Features and Benefits

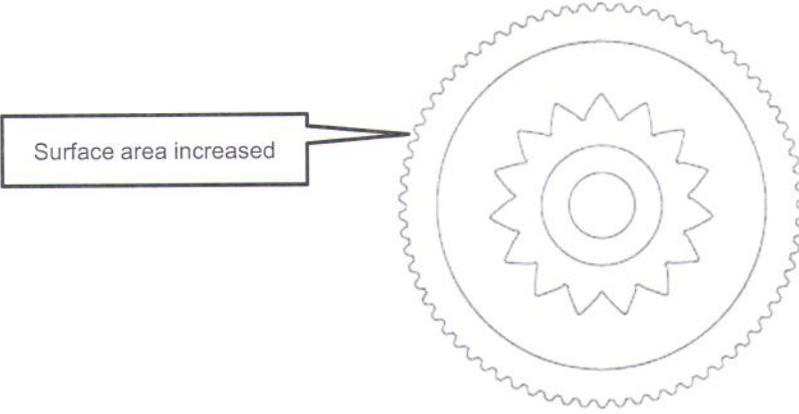
Item	Description
<p>Engine</p> <p>Application: All SRViper models, except early-build</p>	<ul style="list-style-type: none"> • Idler Gear Changes ✓ Different supplier. ✓ Slight increase in gear contact surface area. ✓ Wider gear this year. <ul style="list-style-type: none"> ✓ IMPORTANT <p style="margin-left: 20px;">Gear not interchangeable with previous years: block clearance issue. Only fits new 2016 model 8HK engine. (non early-build models).</p> <div style="text-align: center; margin-top: 20px;">  </div>

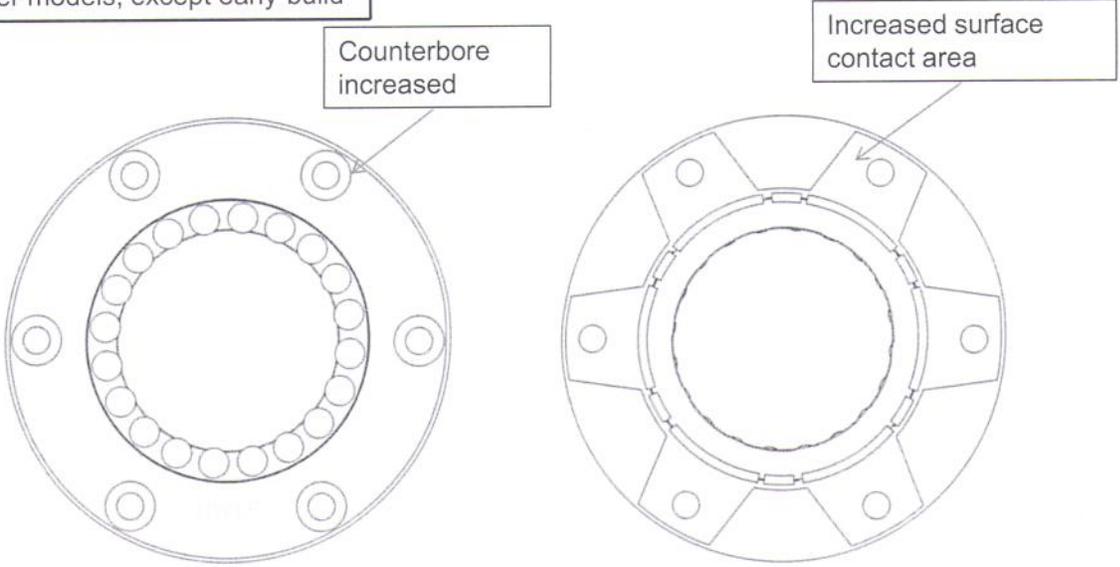
Item	Description
<p>Engine</p> <p>Application: All SRViper models, except early-build</p>	<ul style="list-style-type: none"> • Refined One-Way Starter ✓ Surface contact area increased to rotor. ✓ Fastener counter bore depth increased. ✓ Supplier has changed. <div style="text-align: center; margin-top: 20px;">  </div>
